**CITY OF MERIDIAN
FINDINGS OF FACT, CONCLUSIONS OF LAW
AND DECISION & ORDER**

In the Matter of the Request for Annexation and Zoning, and Preliminary Plat, by Southpoint Estates, LLC.

Case No(s). H-2020-0038

HEARING DATE: 7/14/2020
 TO: Mayor & City Council
 FROM: Joe Dodson, Associate Planner
 208-884-5533
 Bruce Freckleton, Development Services Manager
 208-887-2211
 SUBJECT: H-2020-0038
 Sagewood West Subdivision
 LOCATION: The site is located at 1335 W. Overland Road, between S. Linder Road and S. Stoddard Road, in the NW ¼ of the NW ¼ of Section 24, Township 3N., Range 1W.

B. Preliminary Plat (date: 4/22/2020) (date: 5/27/2020)

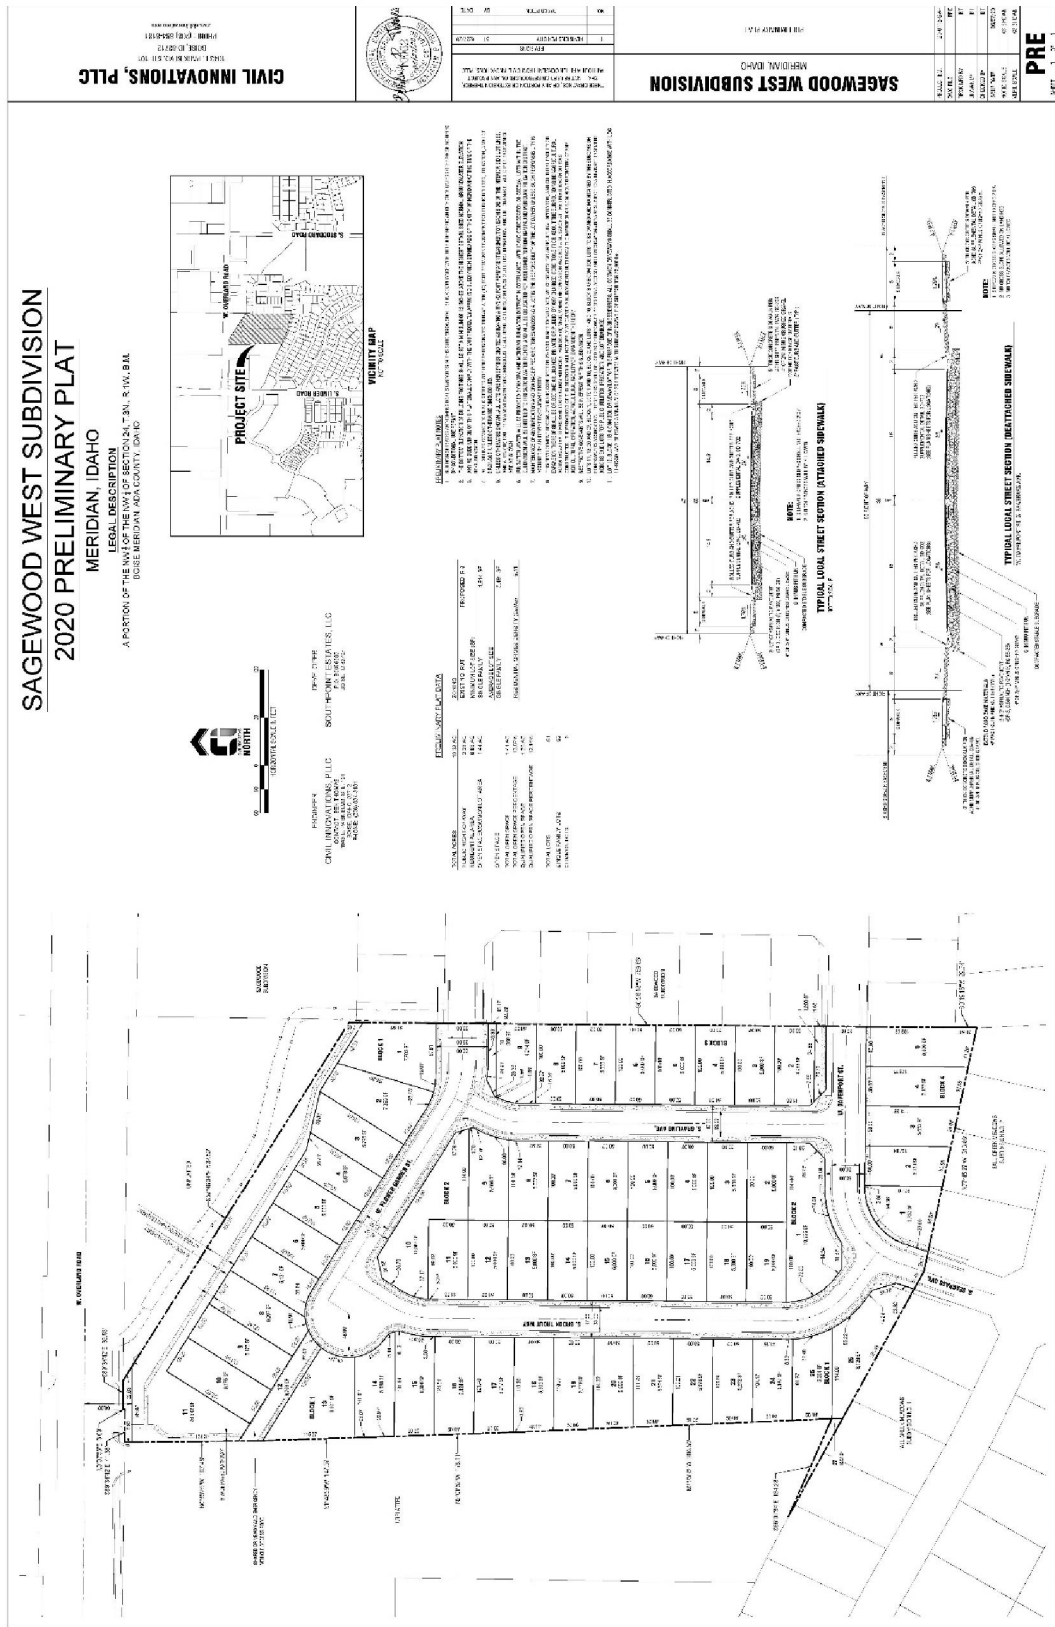
2. Ten (10) days prior to the City Council hearing, the preliminary plat included in Section VII.C, dated 04/22/2020, shall be revised as follows:
 - a. Add a note prohibiting direct lot access via W. Overland Road.

- b. If Nampa Meridian Irrigation District does not allow for landscaping within their easement On Lot 11, Block 1, add five feet of width shall be added on the proposed common lot along the rear of Lots 4-10, Block 1 to accommodate the required landscaping for linear open space.

- d. The applicant shall provide a stub street at the west boundary (Parcel # S1224223270). Location of the stub street shall be coordinated between ACHD, the applicant and the adjacent property owner. If the property develops with a non-residential use, an emergency access shall be provided in lieu of the stub street.

- e. Coordinate with the property owner to the west on the conveyance of the sliver of land located at the rear of Lot 26, Block 1 of the proposed plat. The Applicant shall adjust the boundary of the plat to reflect this change.

D. Landscape Plan (date: 4/3/2020)

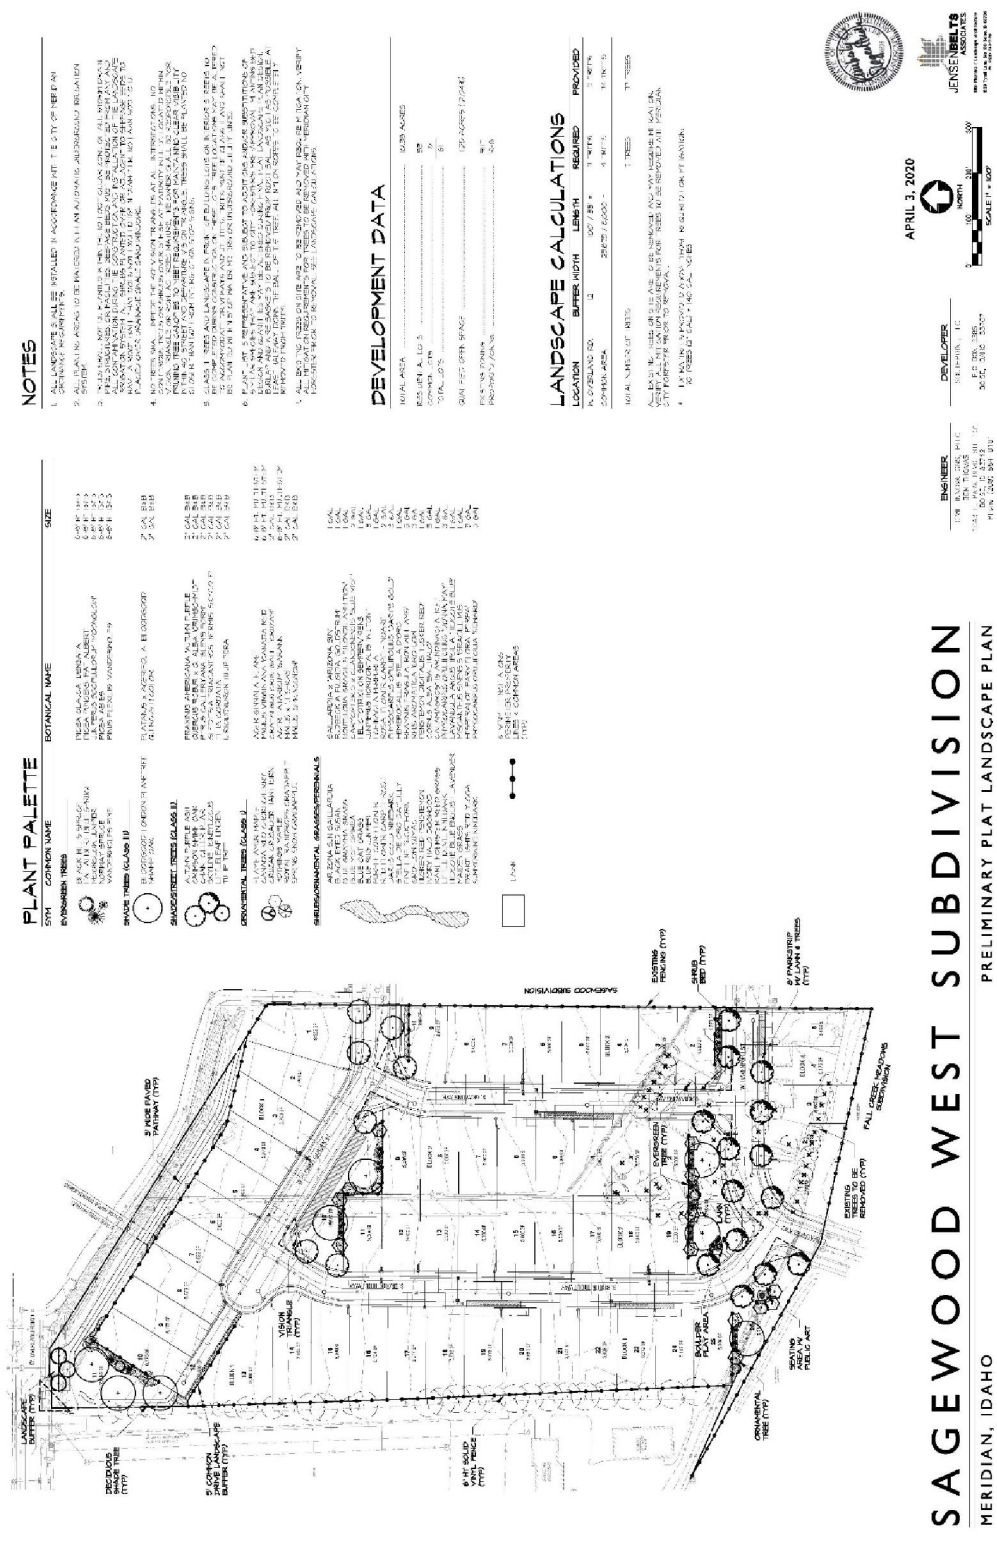
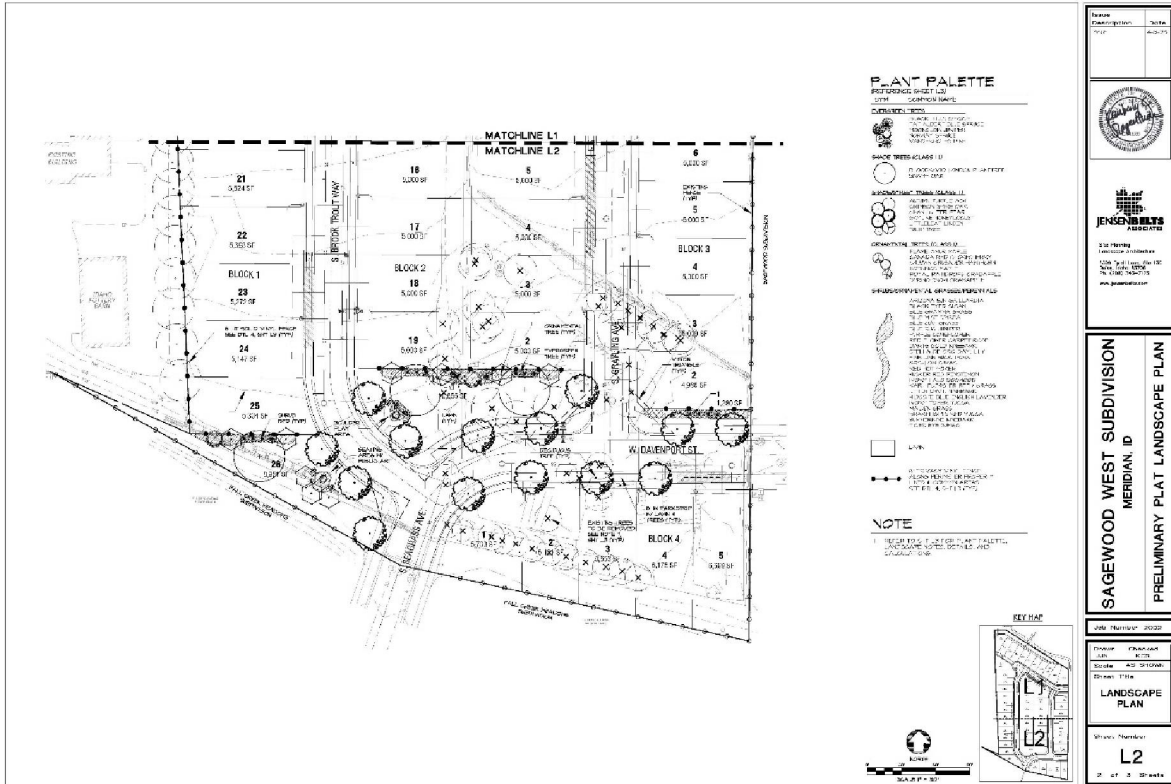
3. The landscape plan included in Section VII.E, dated 04/03/2020, shall be revised as follows prior to submittal of the final plat application:
 - a. Revise landscape plan to show open vision or semiprivate fencing along the common open space and pathway located on Lot 11, Block 1; all fencing shall comply with the standards listed in UDC 11-3A-7.

- b. Revise landscape plan calculations table to include the linear feet of pathway and the required number of trees per the standards in UDC 11-3B-12.

- c. ~~Prior to the City Council hearing,~~ The Applicant shall revise the landscape plan to show an additional five feet of width with landscaping on the proposed common lot (Lot 11, Block 1) along the rear of Lots 4-10, Block 1 to accommodate the required landscaping per the standards in UDC 11-3B-12 if Nampa Meridian Irrigation District does not allow for landscaping within their easement.
